# FIFTH AMENDMENT TO AGREEMENT FOR PROFESSIONAL ENGINEERING SERVICES

Project: Chimney Rock - Project 13203

RE: Project 13203 Chimney Rock Road; Additional Authorization

Re: Amendment 2-Proposal for Professional Engineering Services
Design of Bridge Structures for Proposed Chimney Rock Road over American
Canal and Mustang Bayou, Fort Bend County, Texas
GCE Project No: C-0789

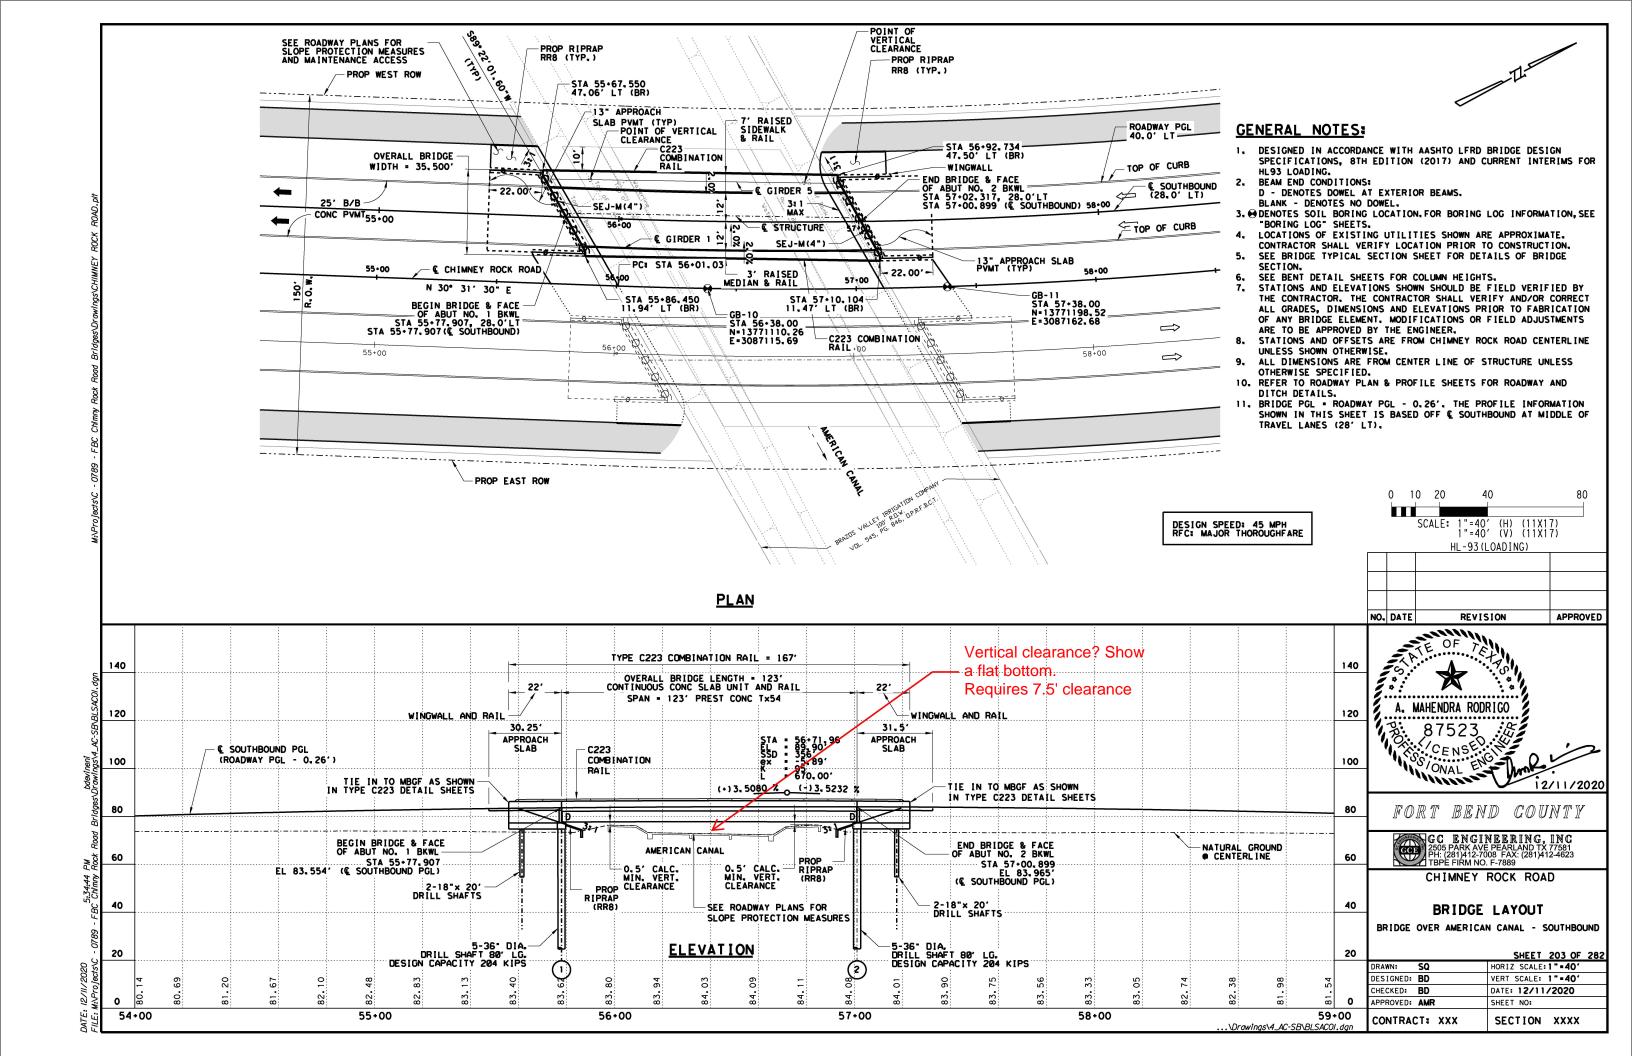
The proposed two bridge structures on proposed Chimney Rock Road over American Canal will be elevated to provide 7.5-feet minimum vertical clearance from the American Canal flowline to the lowest bridge girder, as shown in the attached markup plans. GCE's scope of work shall include the following:

PROP WEST ROW GENERAL NOTES: 1. DESIGNED IN ACCORDANCE WITH AASHTO LFRD BRIDGE DESIGN SPECIFICATIONS, 8TH EDITION (2017) AND CURRENT INTERIMS FOR HL93 LOADING. BEAM END CONDITIONS: D - DENOTES DOWEL AT EXTERIOR BEAMS. 58+00 BLANK - DENOTES NO DOWEL. STA 57+38.00 3.  $\ensuremath{\Theta}$  DENOTES SOIL BORING LOCATION. FOR BORING LOG INFORMATION, SEE 55+00 N=13771198.52  $\leftarrow$ "BORING LOG" SHEETS. E=3087162.68 LOCATIONS OF EXISTING UTILITIES SHOWN ARE APPROXIMATE. -PC: STA 56+01.03 STA 57-25.678 CONTRACTOR SHALL VERIFY LOCATION PRIOR TO CONSTRUCTION. SEE BRIDGE TYPICAL SECTION SHEET FOR DETAILS OF BRIDGE GB-10\_ C CHIMNEY ROCK ROAD STA 56+38,00 12,40' RT (BR) SECTION. 55.00 N=13771110, 26 SEE BENT DETAIL SHEETS FOR COLUMN HEIGHTS. E=3087115.69 57+00 N 30° 31' 30" E STATIONS AND ELEVATIONS SHOWN SHOULD BE FIELD VERIFIED BY C223 COMBINATION -STA 56.03.435 3' RAISED WINGWALL - TOP OF CURB THE CONTRACTOR. THE CONTRACTOR SHALL VERIFY AND/OR CORRECT BEGIN BRIDGE & FACE 12.96' RT (BR) MEDIAN & RAIL ALL GRADES, DIMENSIONS AND ELEVATIONS PRIOR TO FABRICATION FOF ABUT NO. 1 BKWL 1 END BRIDGE & FACE **€** NORTHBOUND OF ANY BRIDGE ELEMENT, MODIFICATIONS OR FIELD ADJUSTMENTS STA 56+11,536, 28,0'RT OF ABUT NO. 2 BKWL (28.0' RT) ARE TO BE APPROVED BY THE ENGINEER. STA 56-11.683 (@ NORTHBOUND) STATIONS AND OFFSETS ARE FROM CHIMNEY ROCK ROAD CENTERLINE STA 57.32.904, 28.0'RT CONC PVMT55.00 57.0060° (TYP) SEJ-M(4") STA 57+34.750 ( NORTHBOUND) UNLESS SHOWN OTHERWISE. - TOP OF CURB ALL DIMENSIONS ARE FROM CENTER LINE OF STRUCTURE UNLESS `— € STRUCTURE OTHERWISE SPECIFIED. SEJ-M(4") REFER TO ROADWAY PLAN & PROFILE SHEETS FOR ROADWAY AND 22,00 13" APPROACH SLAB -13" APPROACH SLAB DITCH DETAILS. -----<del>-----</del> ---PVMT (TYP) PVMT (TYP) BRIDGE PGL - ROADWAY PGL - 0.26'. THE PROFILE INFORMATION ROADWAY PGL SHOWN IN THIS SHEET IS BASED OFF & NORTHBOUND AT MIDDLE OF - 7' RAISED 40.0' RT TRAVEL LANES (28' RT). SIDEWALK & RAIL -C223 COMBINATION RAIL -PROP RIPRAP POINT OF POINT OF PROP EAST ROW OVERALL BRIDGE RR8 (TYP.) VERTICAL VERTICAL WIDTH - 35.500' 0 10 20 80 STA 56+22,402 CLEARANCE CLEARANCE SEE ROADWAY PLANS FOR STA 57+42,526 47.89' RT (BR) PROP RIPRAP MAINTENANCE ACCESS DESIGN SPEED: 45 MPH RFC: MAJOR THOROUGHFARE 48,44' RT (BR) SCALE: 1"=40' (H) (11X17) 1"=40' (V) (11X17) SEE ROADWAY PLANS FOR SLOPE PROTECTION MEASURES SEE ROADWAY PLANS FOR HL-93 (LOADING) SLOPE PROTECTION MEASURES **PLAN APPROVED** REVISION Vertical clearance? Show TYPE C223 COMBINATION RAIL = 167' a flat bottom. 140 140 Provide 7.5' vertical OVERALL BRIDGE LENGTH = 123'
